Planning Officer's Report – LDCA NOVEMBER 2025

APPLICATION	2025/82 – Proposed Security Fence
PERMISSION SOUGHT	Full Permission
REGISTERED	09 September 2025
APPLICANT	Jill Bolton
PARCEL	JT020034
LOCALITY	The Coffee Shop, Jamestown
ZONE	Intermediate
CONSERVATION AREA	Jamestown Historic
CURRENT USE	Coffee Shop
PUBLICITY	The application was advertised as follows: <ul style="list-style-type: none">▪ The Sentinel Newspaper on 11 September 2025.▪ A site notice displayed in accordance with Regulations.
EXPIRY	25 September 2025
REPRESENTATIONS	Two received
DECISION ROUTE	Delegated / LDCA / EXCO

Diagram 3: Site Plan Showing Location of Proposed Fence

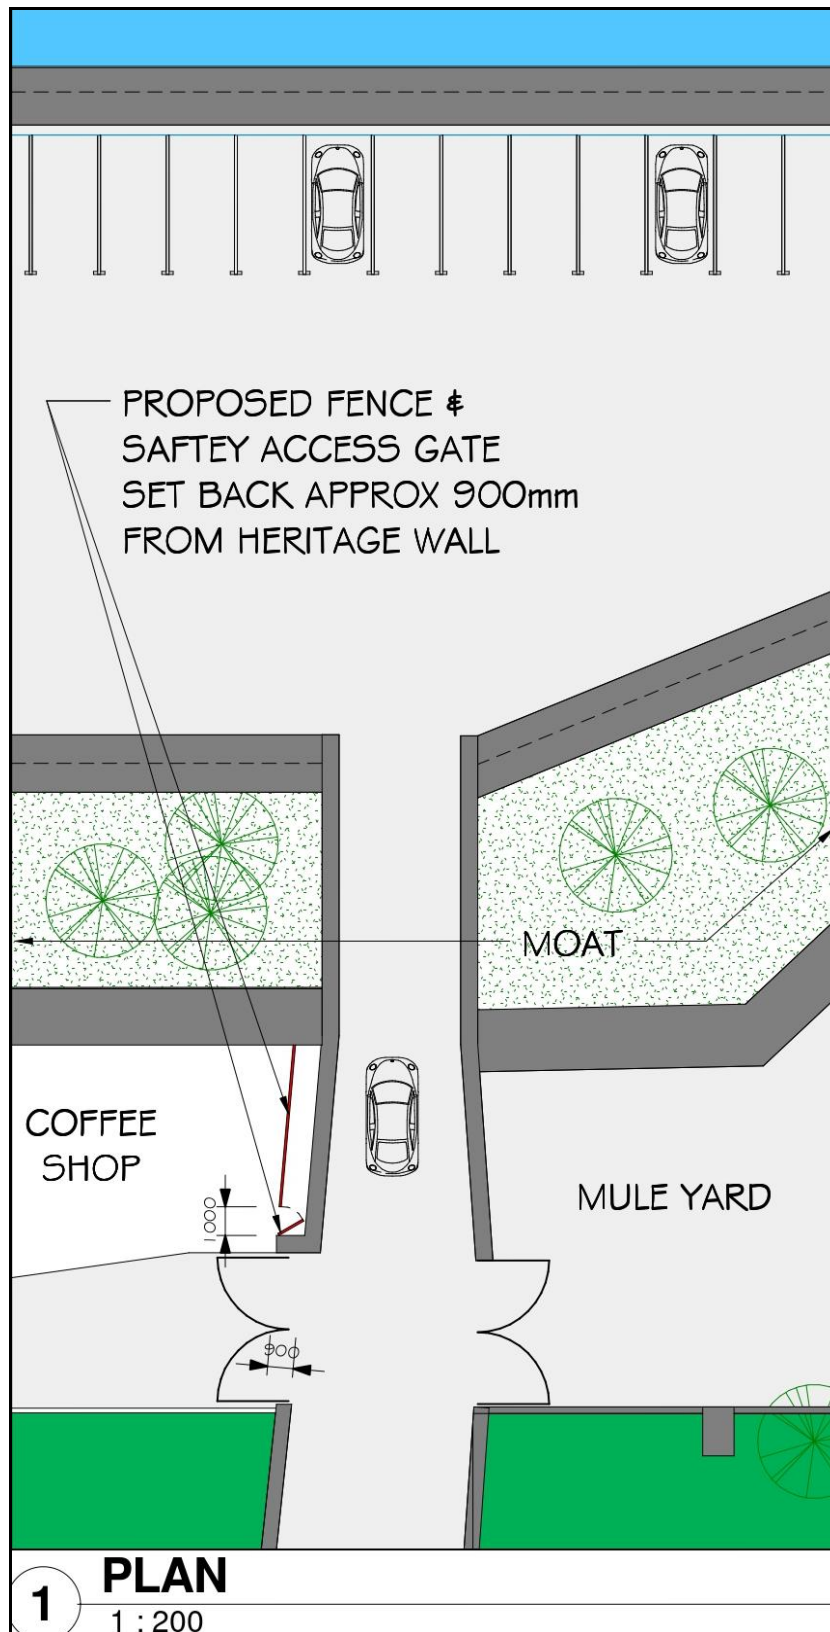
The application form says it is for a Proposed Security Fence. The accompanying drawing is confusing because it does not show just one proposed security fence. There is no detailed plan showing the proposal in relation to the existing lattice gate structure and no elevation from the west. There is no detail of how the proposed fence will be terminated against the moat.

However the proposed 2.9m high fence is well in excess of what the Police indicate would be needed for security purposes and furthermore, the proposed fence projects up over that of the historic boundary wall by more than a metre at the highest point and, although set back from the boundary wall by just under 1m (900mm) it will appear prominent and visible from public viewpoints in the surrounding streetscape such that this proposal to install a security fence consisting of chain link fencing is not in keeping with any of the heritage features that faces directly on to the streetscape.

Diagram 4: East Elevation Showing Chain Link Fence

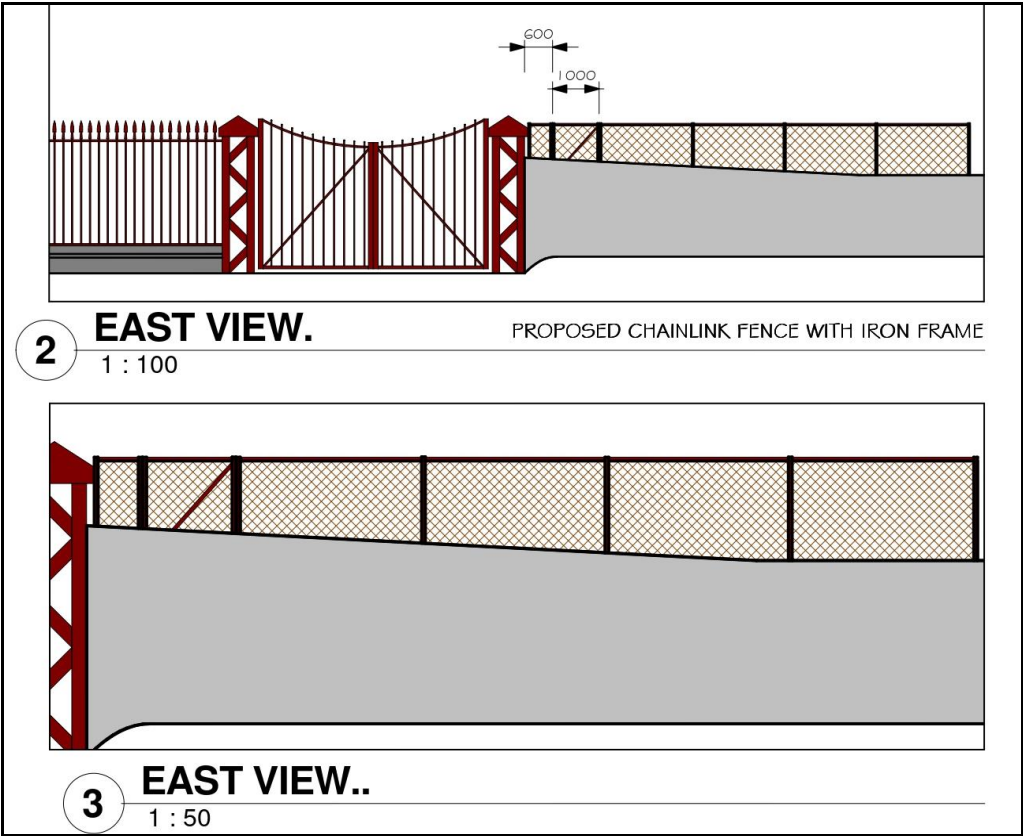
In considering the development proposal for a security chain link fence with iron frame, in accordance with the relevant policies, the design, material, scale and siting of the fence is not considered to contribute to the conservation of, nor enhances the aesthetic of the heritage streetscape of which it will be a part of, that is the bridge leading through *The Arch*.

Therefore, and to conclude this assessment of the proposal, the overall design of the chain link fence is not in line with LDCP Policies BH1 and BH2, in that it is not complimentary of existing features and does not add to the character or support the conservation of the Jamestown Historic area.
